Request of Class II Permissive Change

FCC ID: APIJBLXTREME3N

This is to request a Class II Permissive Change for FCC ID: APIJBLXTREME3N originally granted on 03/04/2021, due to battery cell added.

Battery:

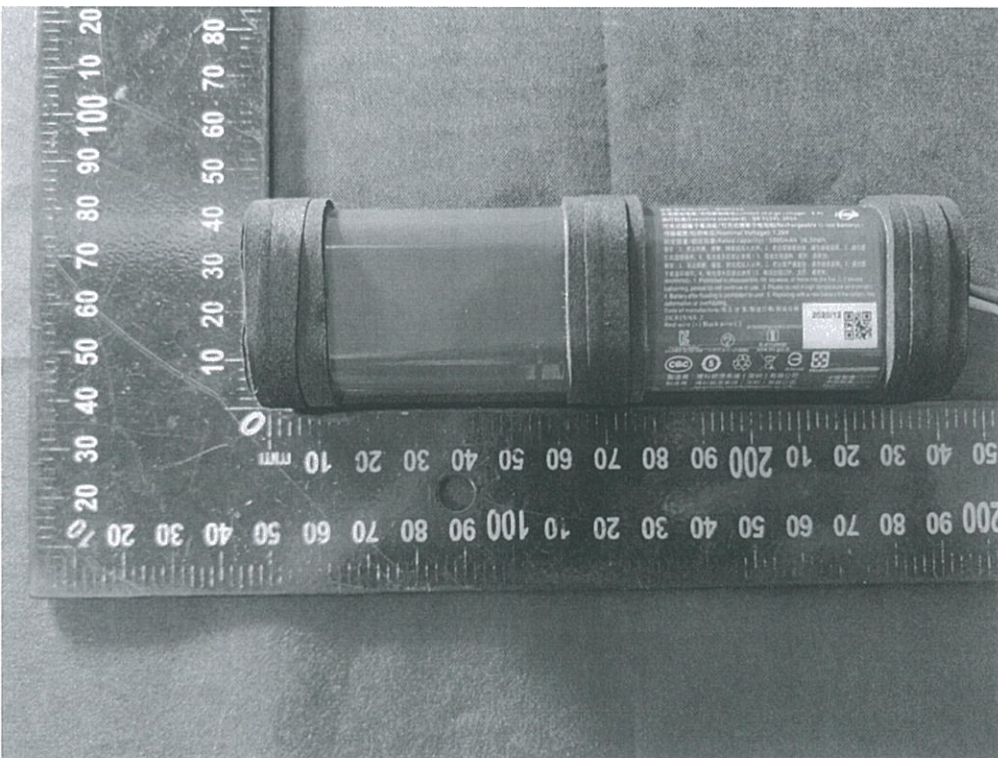
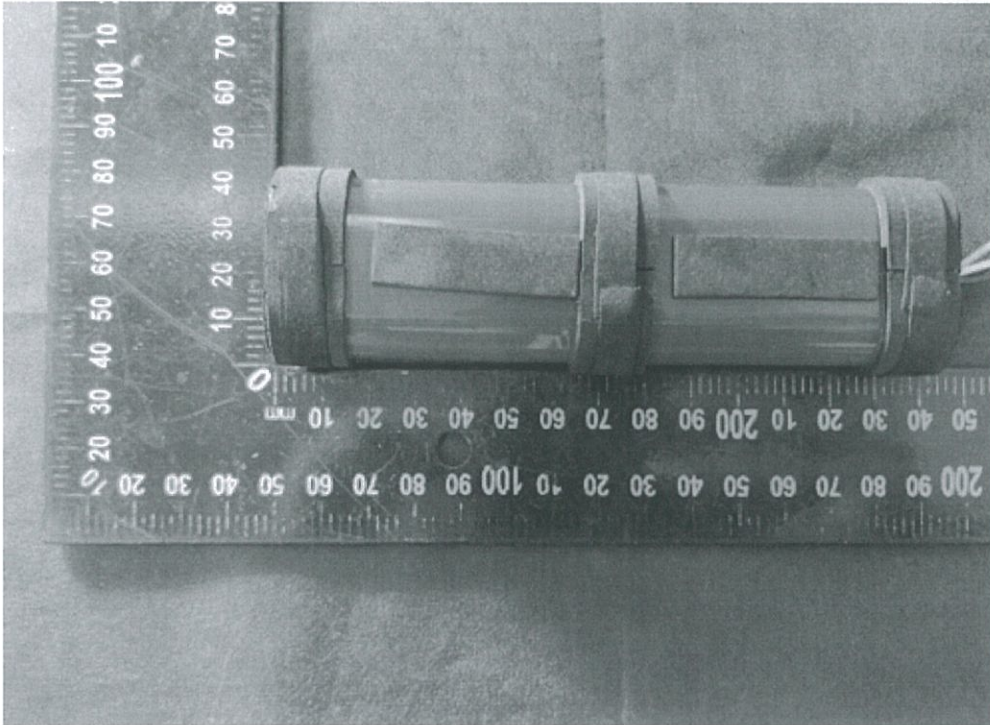
The major change filed under application is:

Battery		Manufacture	Model	Description
	Original	ICON ENERGY SYSTEM (SHEN ZHEN) CO., LTD.	IBA001GA	Rated Capacity: 7.26V 5000mAh 36.3Wh; (TI IC BQ27750)
	New	ICON ENERGY SYSTEM (SHEN ZHEN) CO., LTD.	IBA001GA	Rated Capacity: 7.26V 5000mAh 36.3Wh; (TI IC SH366003)

The newly added battery cell will affect the performance of Radiated Emission

(30 MHz – 1GHz) and Power Line Conducted Emissions, and C2PC applied for this.

New Battery IC: TI IC SH366003
